RGDSS Memorandum

Subject: RGDSS Peer Review: Review of wells and areas of high model residuals

Date: June 22, 2015

Figure 2: widely dispersed wells in south central SLV.

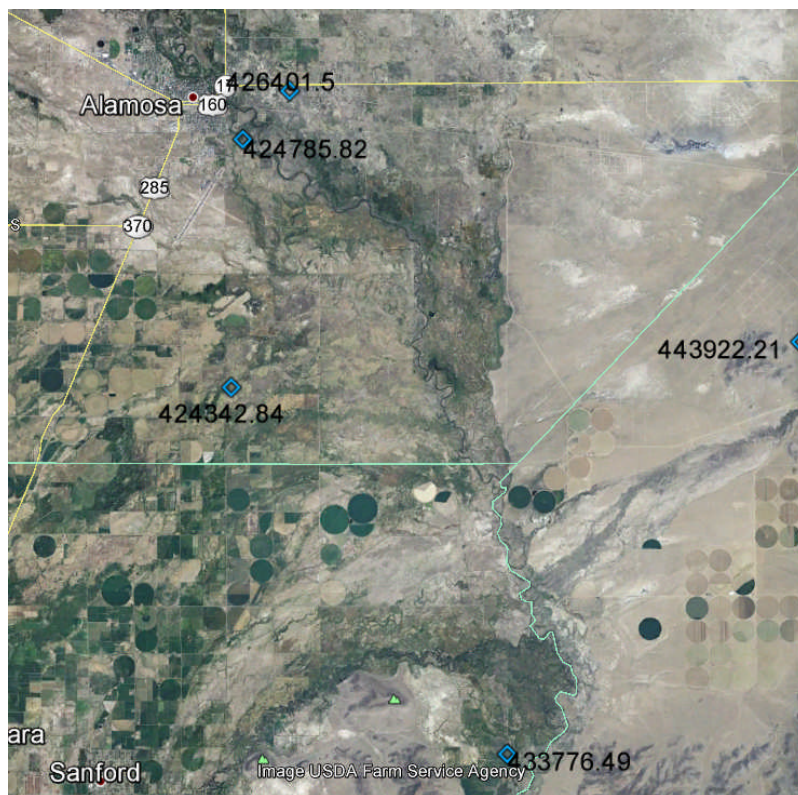
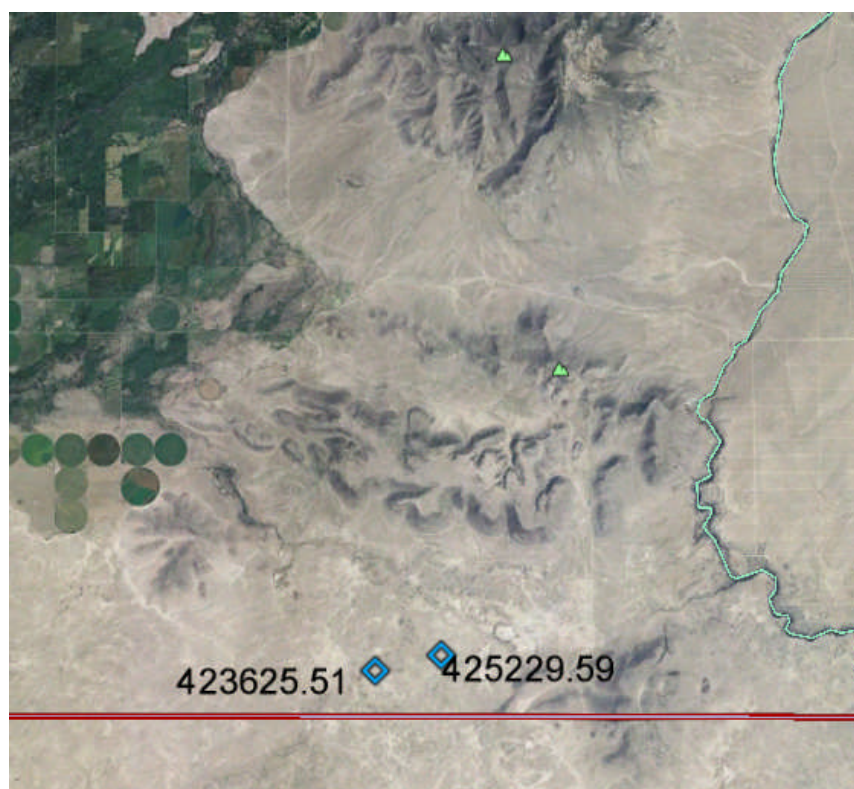
Of these nine wells, we recommend that 7 be omitted from the calibration data set. Three confined aquifer wells have shown anomalously deep water levels (permit no. 32092, 33063, 30630) in areas where confined aquifer potentiometric head is high, and wells in aquifer layers L3 and L4 commonly flow. All three of these showed errors in the driller's well completion report: all three wells reportedly flowed at the time of completion, but the driller erroneously reported the depth where ground water flow first was encountered (600', 600', 750' respectively). Several wells are completed in low-permeability Conejos Formation near the edge of the San Luis Hills, and should not be used to represent confined aquifer conditions in the productive layers L3 and L4. Two wells are located in Punche valley, and in our opinion are correctly assigned to L3 (see Figure 3).

Recommended calibration weighting changes: Reduce weighting of Punche valley wells due to relative isolation from SLV aquifer layers due to low hydraulic conductivity (K) in the San Luis Hills.

Recommended future investigations: none.

Recommended future modeling and sustainability metrics enhancements: None of the wells in this group are recommended for inclusion in future enhancement of sustainability metrics.

Figure 4: Wells near the southern flank of Mt. Blanca.

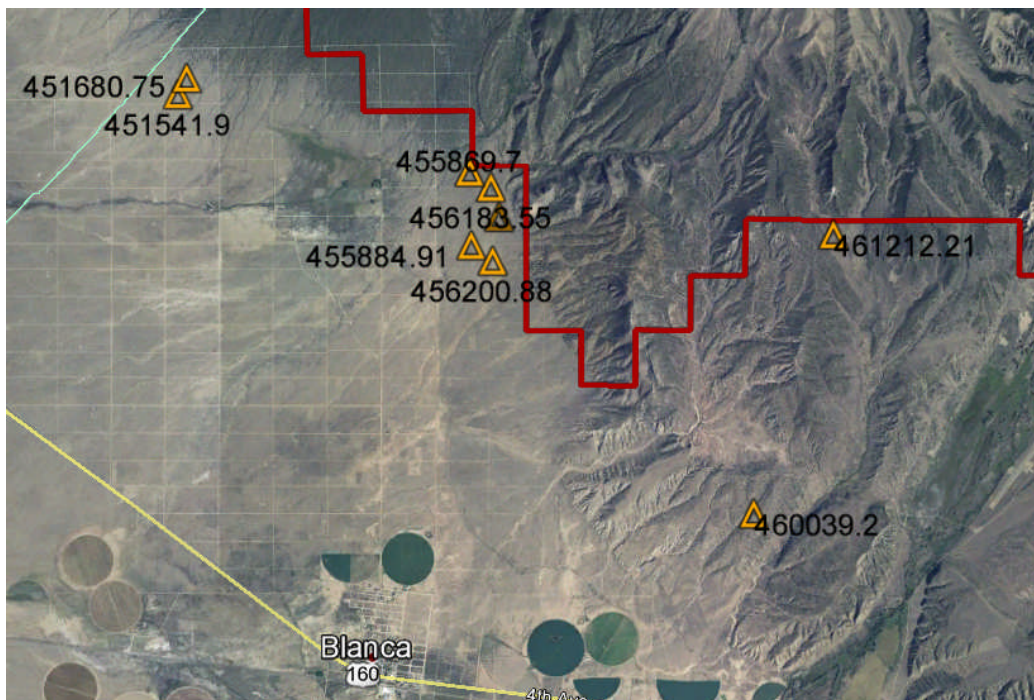
Two wells in this locality are recommended to be omitted from the calibration set. One is probably in an isolated zone of bedrock, and the other is approximately 600 feet in elevation above the adjacent valley floor, and is unlikely to represent the regional water table. Although the majority of the wells in this zone are correctly assigned to model layer 1 (L1), the large negative residuals suggest that there may be a hydrogeologic reason for the high residual – possibly a perched water table due to stratification not seen in driller’s logs, or possibly an isolated fault block (the area is very near mapped splays of the Sangre de Cristo fault).

Recommended calibration weighting changes: Reduce weighting of L1 wells in this group due to high potential for perched water table or fault block isolation from SLV aquifer layers due to close proximity to mapped faults.

Recommended future investigations: Check to see whether USGS aeromagnetic coverage suggests fault isolation for any of these wells.

Recommended future modeling and sustainability metrics enhancements: None of the wells in this group are recommended for inclusion in future enhancement of sustainability metrics. These

Figure 5: Urraca Canyon and Zapata Subdivision high residual wells.

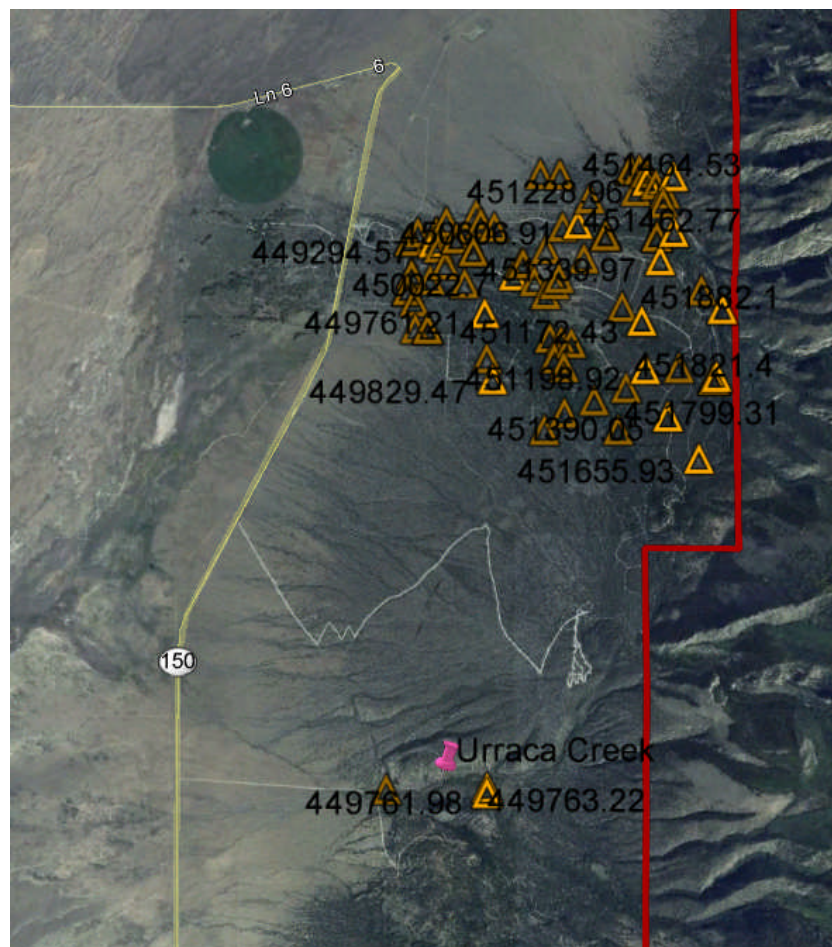
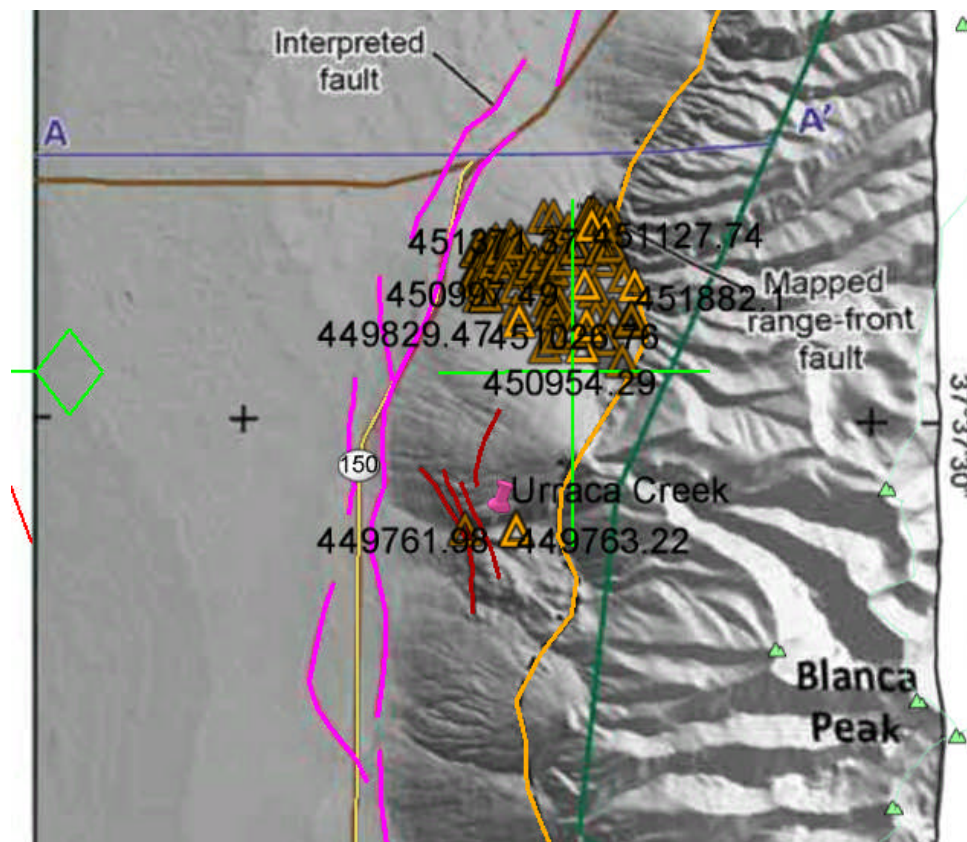
All of the wells in this group (which are all currently assigned to L1) have high negative residuals ranging between approximately 100 and 1,000 feet. The driller's reports for several of the wells checked in this area show typical alluvial fan material – sand and gravel – overlying what appears to be hard, cemented sedimentary rock ranging from red to green and gray. This strongly suggested to us that there may be an elevated block of older, pre-rift bedrock formations that underlies the unconsolidated alluvial fan deposits this area. A check with U.S. Geological Survey researchers showed that there is a recently-published tentative interpretation of a fault block in this area¹, covered by the alluvial fan, that may indeed isolate this area from the SLV regional water table, and cause locally elevated water levels, particularly in the Zapata Subdivision wells. This interpreted faulting is shown on Figure 6.

Recommended calibration weighting changes: Defer the use of wells in this group for the present time. There is a high potential for these wells to represent a perched water table or fault block isolated from SLV aquifer layers due to close proximity to mapped faults and a potential high elevation bedrock block in the subsurface. There are 87 high-residual wells in the Zapata Subdivision – approximately 1/3 of the total number of wells in the list of 268 high-residual provided by Principia. Due to the potential for fault isolation and/or perching, it is possible that very few if any of these wells are representative of the SLV sedimentary aquifer layers.

Recommended future investigations: Follow up with USGS researchers, and use the new information to develop revised aquifer mapping along the Mt. Blanca reach of the Sangre de Cristo mountain front.

Recommended future modeling and sustainability metrics enhancements: All wells in this group should be deferred from inclusion in sustainability metrics until completion of revised mapping, a revised estimation of whether or not any of these wells are reflective of the SLV aquifer layering, and revised model calibration.

Figure 7: Wells in Crestone and vicinity.

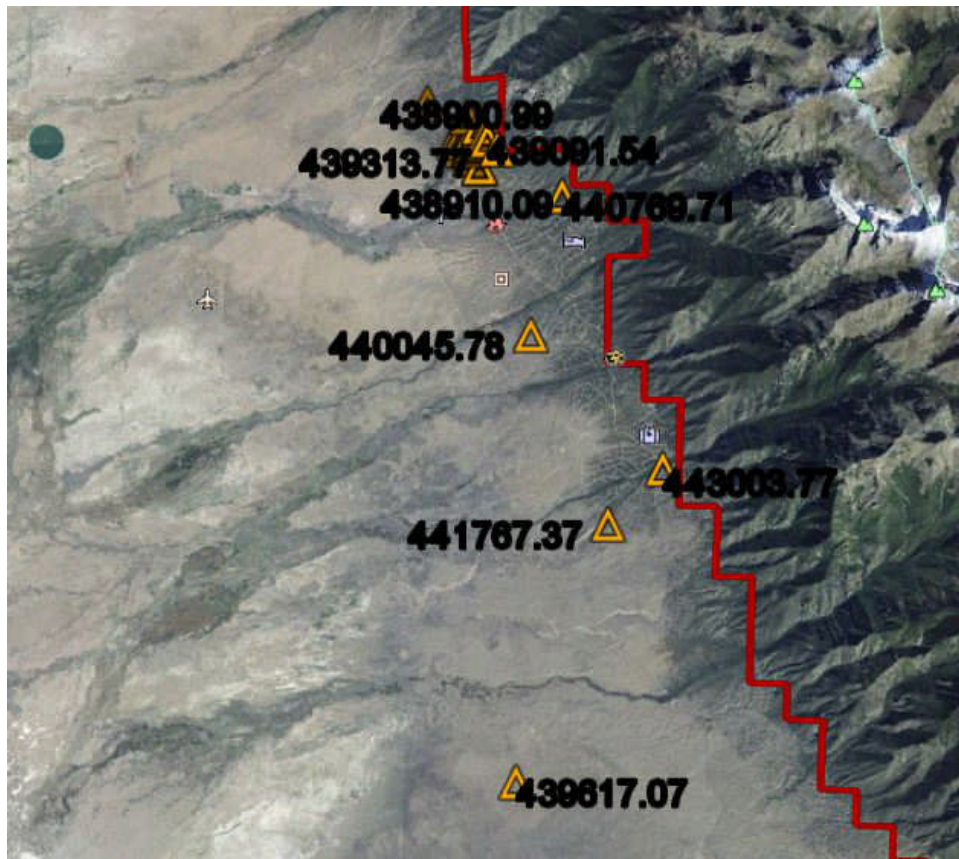
The four wells in this area all are assigned to L1. One of these (permit no. 221139) is more likely reflective of L2, as it appears to be confined by a series of thin clay layers. Two wells are recommended for omission, as we suspect they may be located on a bedrock bench with overlying alluvial fan materials. The fourth well appears to be properly assigned to L1

All 28 of the high-residual wells in or near the town of Crestone currently are assigned to L1. We recommend that all 28 be deferred from inclusion in the calibration set at present, because we suspect the presence of a buried bedrock 'bench' beneath near-surface fan alluvium. All of

the five wells in this sampling that we reviewed showed typical high-energy alluvial near-apex fan material: cobbles, boulders, gravel, sand, with minimal clay and silt. However, all water levels are relatively shallow – generally less than 100 feet – which would probably not be the case if there were no low-permeability layers extent at a relatively shallow depth beneath the coarse-grained alluvium.

Recommended calibration weighting changes: Defer the use of wells in the Crestone area for the present time. There is a high potential for these wells to represent a perched water table due to a potential high elevation bedrock block buried beneath the coarse alluvium in the subsurface. There are 28 high-residual wells in the Crestone area – approximately 10% of the total of 268 high-residual wells in the list provided by Principia. Due to the potential presence of buried bedrock step causing locally elevated water levels, it is possible that few of these wells are representative of water levels in the SLV sedimentary aquifer layers.

Recommended future investigations: Follow up with USGS researchers regarding the northern extension of recent high-resolution aeromagnetic geophysical surveys, and use the new information to develop revised aquifer mapping along the Crestone / Baca reach of the Sangre de Cristo mountain front.

Recommended future modeling and sustainability metrics enhancements: All wells in the Crestone subgroup, and all but two in the area just south of Crestone, should be deferred from inclusion in sustainability metrics until completion of revised mapping and a revised estimation of whether or not any of these wells are reflective of the SLV aquifer layering, and revised model calibration.

Figure 8: High residual wells in the San Luis Creek and NE Sangre de Cristo mountain front area.

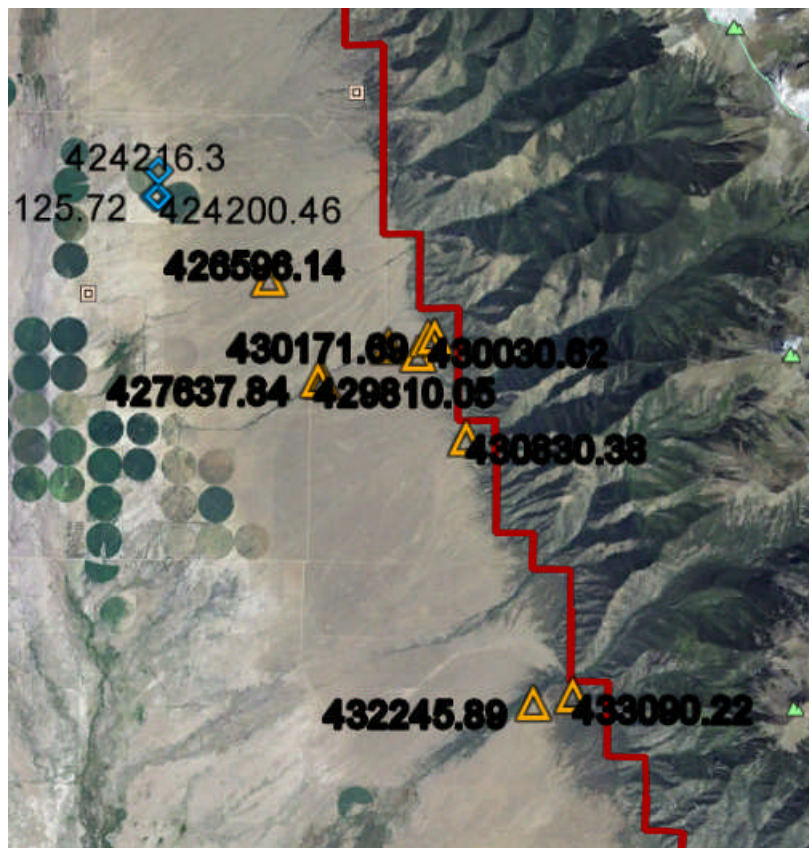
The four high-residual wells in this sub-area generally show an alluvial sequence of sand/gravel, with some clay layers noted. One well is a duplicate, and is recommended for omission so as not to inordinately weight this point in the calibration. Two of the wells are suspected to be currently assigned to the wrong model layer.

The nine wells in this sub-area all are currently assigned to L1, but range in depth from 120 to 775 feet, and eight wells show some clay layers interbedded with coarser alluvial fan material. The two wells in the Rito Alto Creek area (southernmost wells on Figure 8) are recommended to

be omitted due to either possible perching on a bedrock fault block or possible recharge from the creek. We suspect that all the wells are more reflective of L3 water levels than L1, and we recommend layer reassignment.

Recommended calibration weighting changes: One of the wells in the San Luis Creek sub-area is recommended for omission, as it is duplicative, and if honored, it would inordinately weight this data point. Two of the well in the NE Sangre de Cristo Mtn. Front sub-area are recommended to be omitted as the static water levels are not reflective of the regional water levels in any of the model layers.

Recommended future modeling and sustainability metrics enhancements: The commonality of current L1 layer assignments to wells on the alluvial fan ranging from approximately 120 to 700+ feet deep, coupled with the presence of clay in these wells, suggests to us that it may be advisable to review the Sangre de Cristo fan area to see whether there is sufficient data, and sufficient hydrogeologic justification, to warrant revising aquifer mapping near the Sangre de Cristo mountain front in this vicinity. No sustainability metrics enhancements are recommended at this time.

Figure 9: upper San Luis / Poncha Pass area

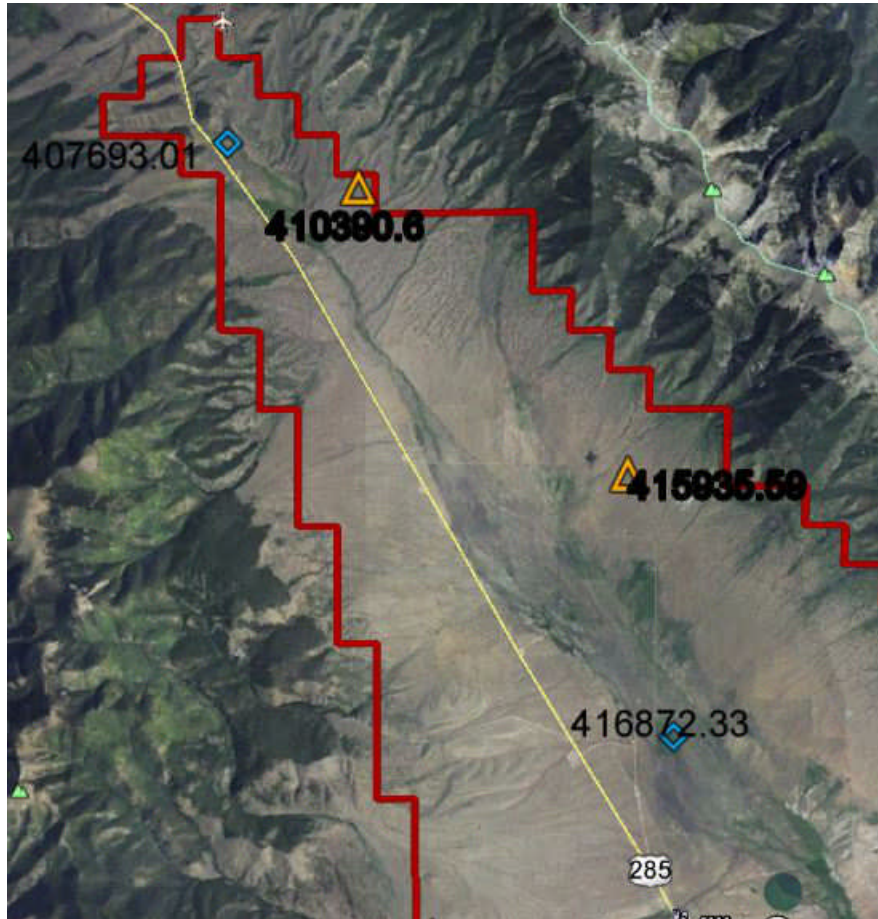
There are four wells in this area (see Figure 9). Of these four, only one was found from well records as likely to be reflective of SLV aquifer layering. The other three are recommended for omission from the calibration set: one is reportedly completed entirely in granite, and two are high up on an alluvial fan NE of San Luis Creek. These latter two both show relatively shallow water table, but are between 300 and 400 feet in elevation above the adjacent stream valley. We therefore suspect that these are probably perched water levels, or are otherwise not reflective of the regional water table in the SLV aquifer layers.

Recommended calibration weighting changes: Three of the four wells in the Poncha Pass area are recommended for omission, as discussed previously. The fourth is recommended for layer re-assignment to L2 instead of L4, as it is currently assigned.

Figure 11: Mineral Hot Springs / NW alluvial fan area.

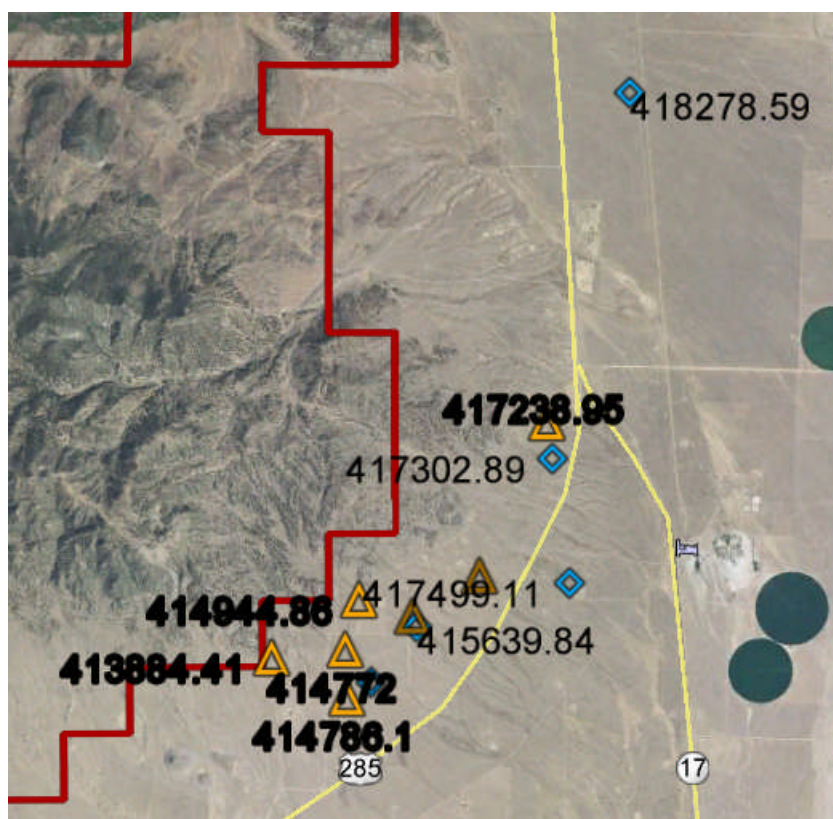
There are 12 wells in this area (see Figure 11), of which HRS reviewed records from seven. Of these seven, only one was found from well records to be reflective of SLV aquifer layering. The majority of the high-residual wells in this area, based on well records, are completed in what is described as “granite”, “gray granite”, or “gray volcanic rock”. From this, we recommend omission of all wells in this area from the calibration set, with one exception (well permit no. 239601), which appears to be completed in L3. This is a recommended re-assignment from L4, the current layer assignment for this well.

Recommended calibration weighting changes: With one exception, all wells in the Mineral Hot Springs / NW alluvial fan area are recommended for omission, as discussed previously.

Recommended future modeling and sustainability metrics enhancements: With the exception of Well permit no. 239601, we recommend that none of the wells in the Mineral Hot Springs / NW alluvial fan area should be included in sustainability metrics, as wells in this area do not appear to be reflective of water levels in the SLV aquifer layers represented in the RGDSS model.

Figure 12: Carnero Creek alluvial fan area.

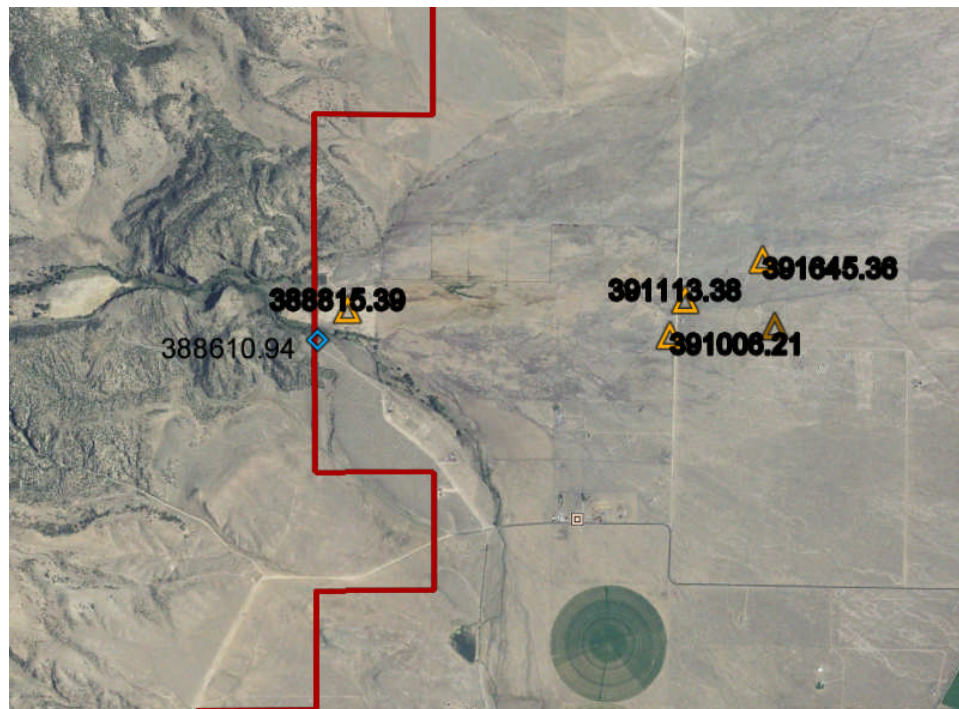
There are 6 wells in this area (see Figure 12), of which HRS reviewed records from all six. Of these six, two are recommended for omission from the calibration set: one due to a suspected perched water level, and one is completed in the Conejos Formation, and is not reflective of the SLV aquifer layers represented at this location. Of the remaining 4 wells, only one layer reassignment has been recommended.

Recommended calibration weighting changes: Two of the six wells in this are recommended for omission, as discussed previously. One is recommended for layer reassignment.

Recommended future modeling and sustainability metrics enhancements: With the exception of the two recommended omissions, the other wells in this area, in our opinion, would be suitable for inclusion in future sustainability metrics.
